**ACME TOWNSHIP PARKS & TRAILS MEETING**  
**ACME TOWNSHIP HALL**  
**6042 Acme Road, Williamsburg MI 49690**  
**June 16<sup>th</sup>, 2017 8:30 a.m.**

**From:** Wiest, Jeremy (MDOT) [mailto:WiestJ@michigan.gov]  
**Sent:** Monday, June 12, 2017 7:01 AM  
**To:** Kevin Krogulecki <kskrogulecki@goslingczubak.com>  
**Cc:** Klaus Heinert <kdheinert@goslingczubak.com>  
**Subject:** RE: North Bayside Park - Acme Twp. - US-31 Drive Opening Sketch

### NORTH BAYSIDE PARK - US-31 DRIVE OPENING

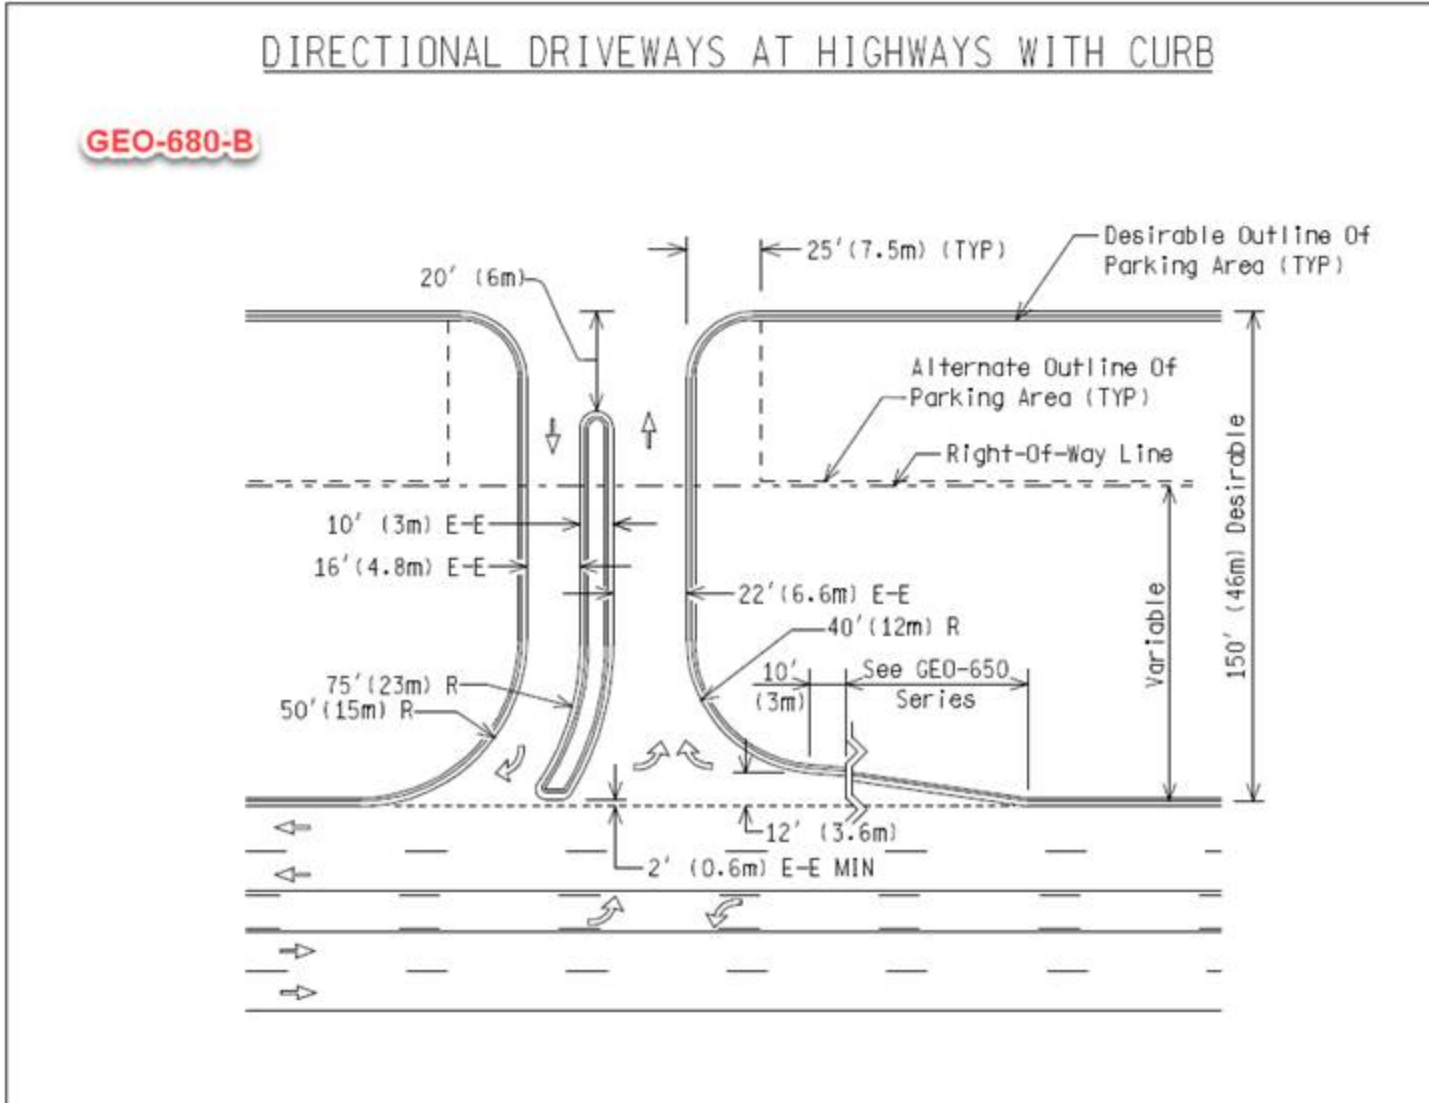
I have discussed this with Krista and have two minor comments.

- 1.) We know you are constrained by the power pole and the catch basin but we were wondering if there would be any way to get a little bigger radius on the north curb. A 20 foot radius is on the

small end and if you were able to increase it even 5 feet it would make it easier for a vehicles making the right into the driveway.

2.) The curb island needs to be set back 2 foot as shown in GEO-680-B, below.

Thanks for getting back to us on this and providing the comments below. We have made the suggested layout changes and attached is our latest layout that we would like to pursue.

Edge of metal radii have been standardized at 25'. This widened our opening a little, and given our constraints we would like to shift the opening slightly north. This would do a couple things:

- Help improve one-way/directed vehicular circulation within the parking lot area of our site. This driveway shift forces entering vehicles to immediately turn right once they have traveled past the driveway.
- Gets us further away from the power pole to the south, as well as a steeper slopes to the south which fall off of the existing asphalt parking lot
- Adhere to 25' Radii standards. Final location of the proposed grate inlet would be tucked far enough north that it will be out of the way of vehicle tire traffic when entering the site.

The only request would be to swap out the existing north end curb and gutter inlet with a flush gutter inlet. This may require a new man hole cover as well, but ideally we would like to just swap inlets using the same cover and preventing any disruption of existing road asphalt. As discussed, we plan to keep hand patching of the asphalt road to an absolute minimum, given there will even be a need.

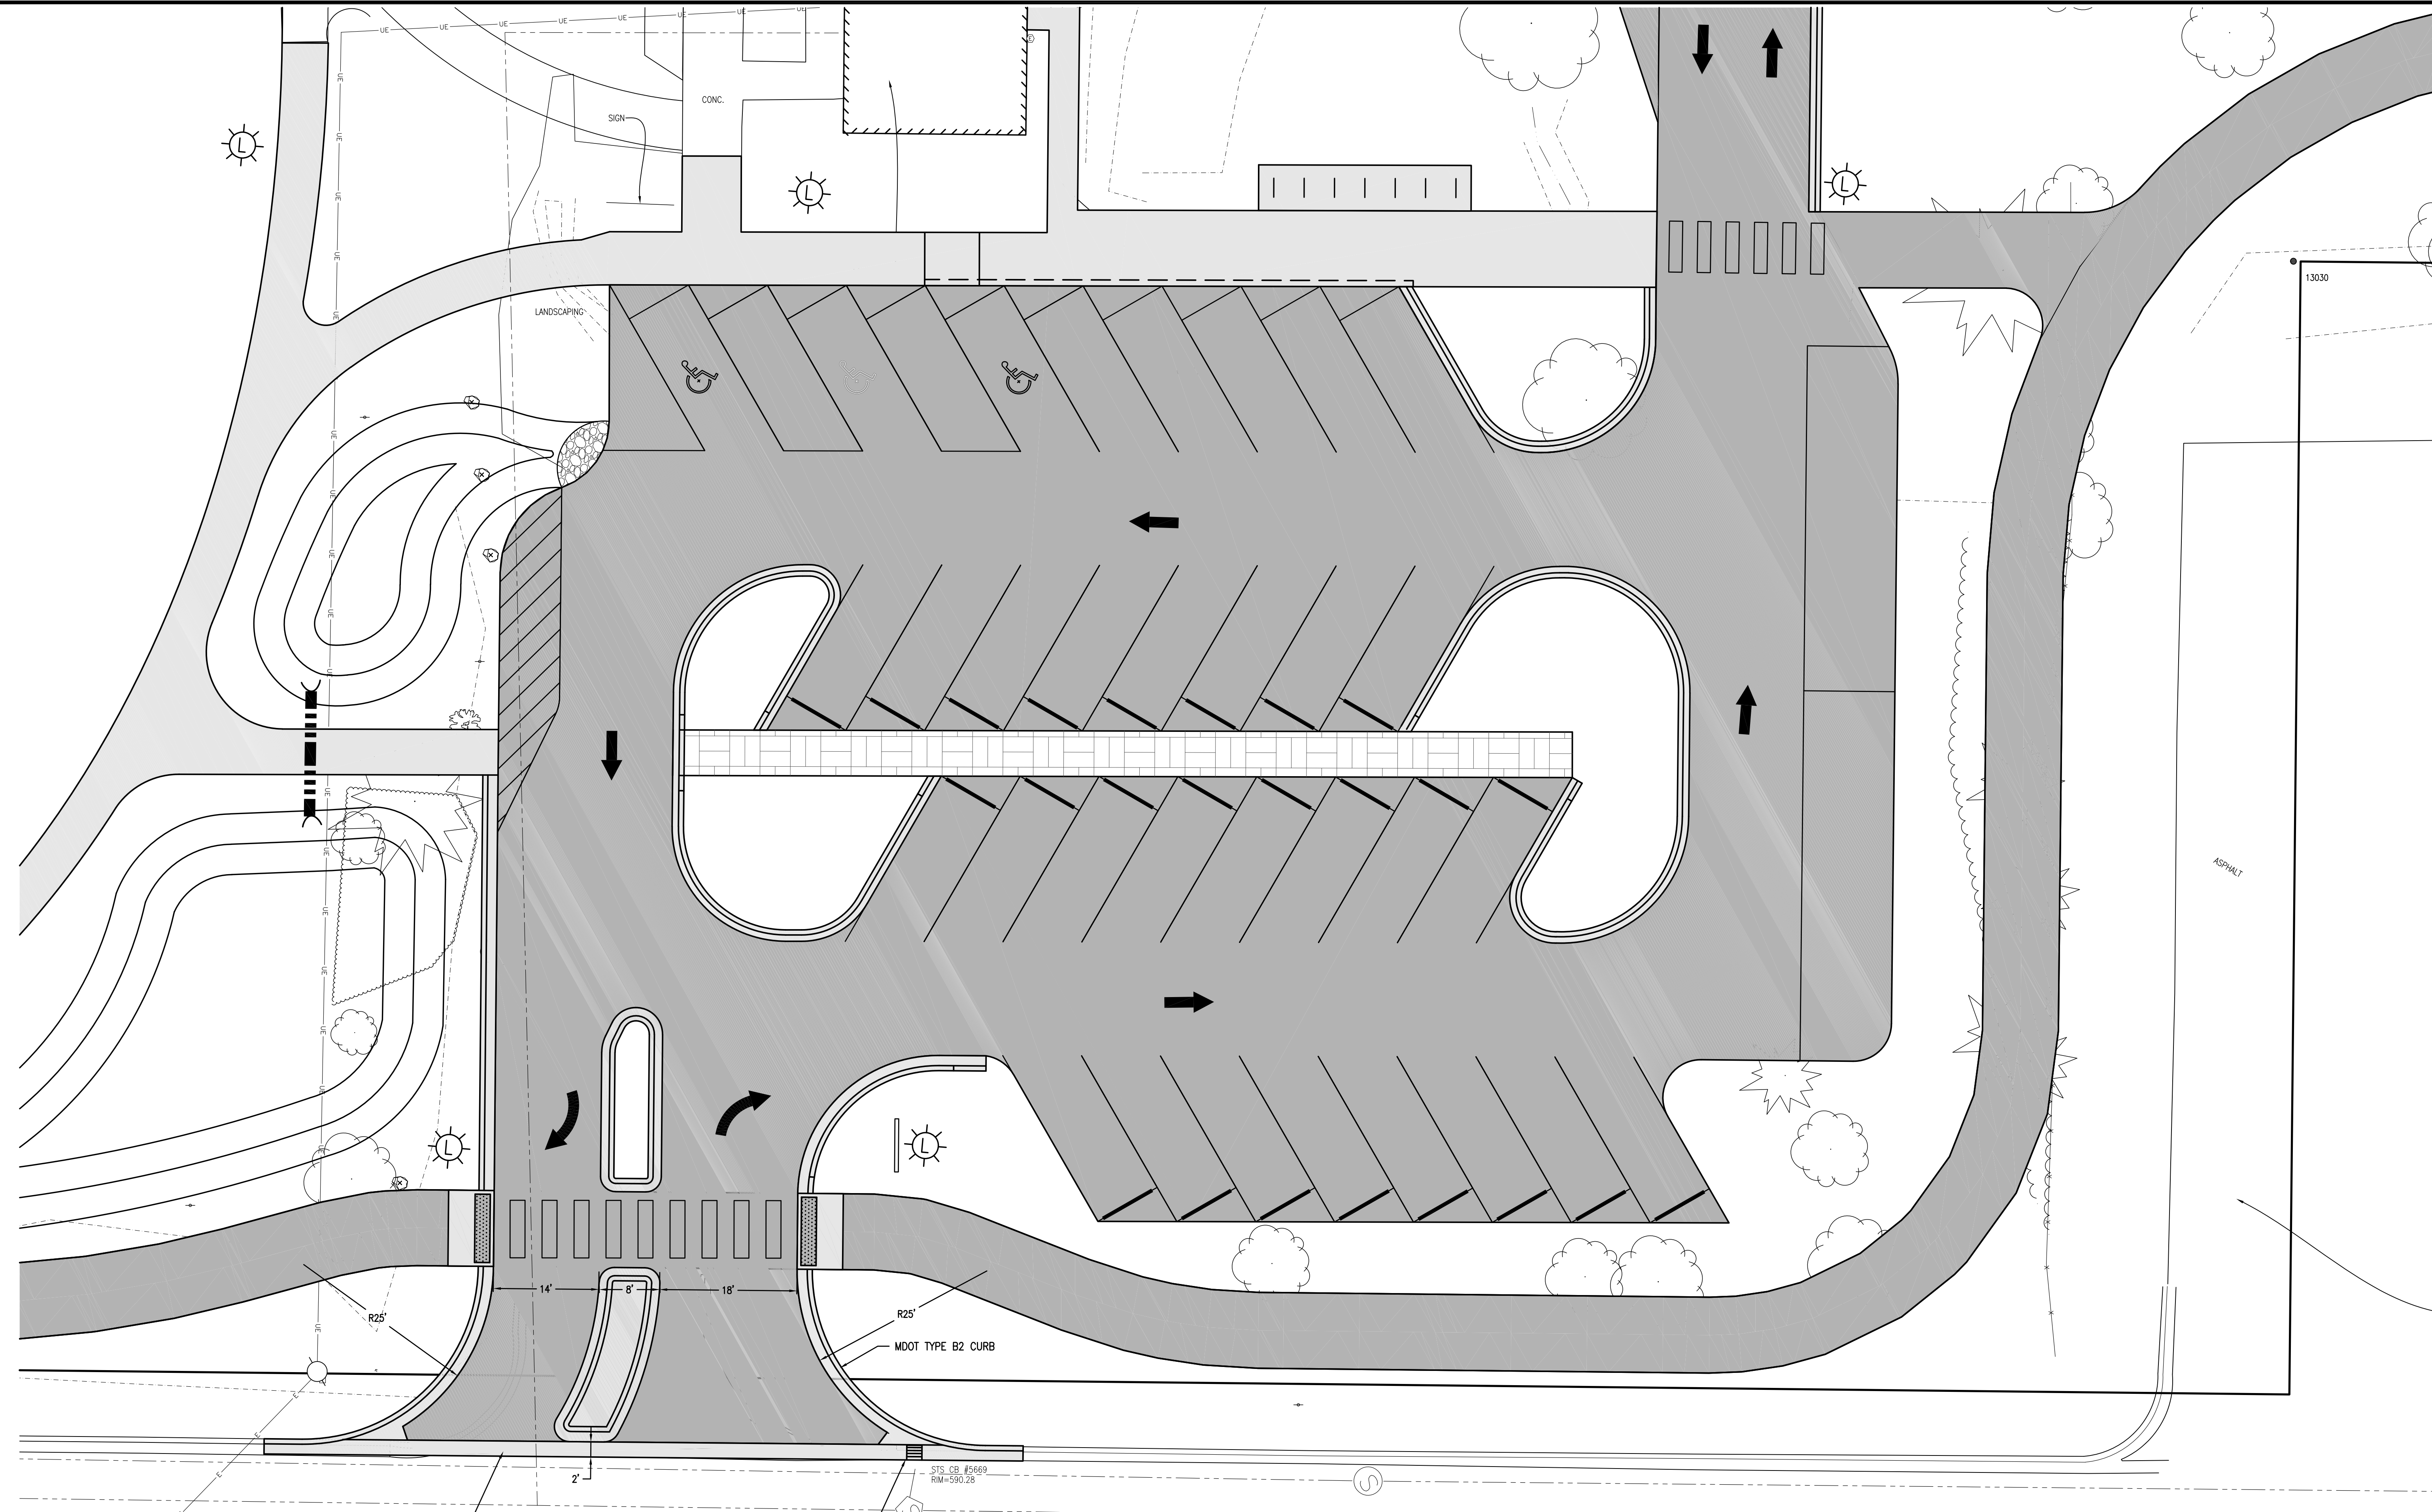
We put together a quick sketch for a driveway opening to US-31 from the park. It introduces a directional driveway with center island limiting drivers to a right-turn-only out of the park in this location. As you can see we are working with pretty tight constraints due to the power pole to the south and existing catch basin to the north (we would like to keep the opening within these limits, basically giving us a width of 40'+/- max to work with).

Just wanted to get your thoughts before we get to far along. Would something like this be possible given allowed deviation from your standard details? Would you have any suggestions or other similar project examples that would apply to this scenario?

FYI the attached drawing shows our latest proposed US-31 driveway entrance to North Bayside Park. Jeremy from MDOT has reviewed the layout and they are OK with the proposed design.

I have discussed your newest layout with Krista and we are accepting of it.
